**Re: Site Plan Control Application – 2830 Carling Avenue and 810 Vick Avenue  
File Number: D07-12-20-0163**

This letter contains our responses to the third round of review comments as issued by the City of Ottawa on August 4, 2021. Please note the following abbreviations:

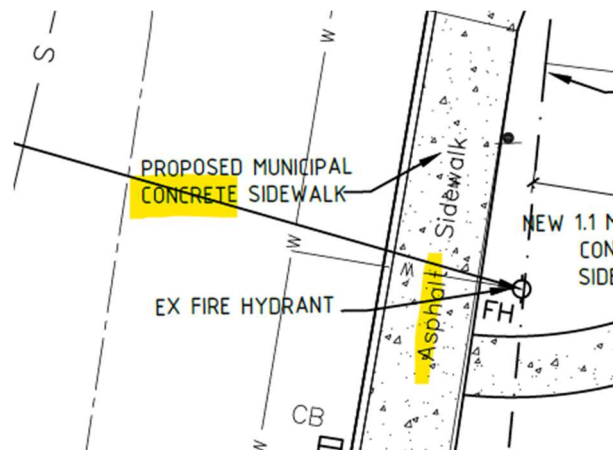
7. The current planting plan provides a total of 14 replacement trees within the municipal ROW. This permits a reduction in compensation of \$5,600.00, resulting in deficit of \$10,314.75.

Response (HCI): Noted.
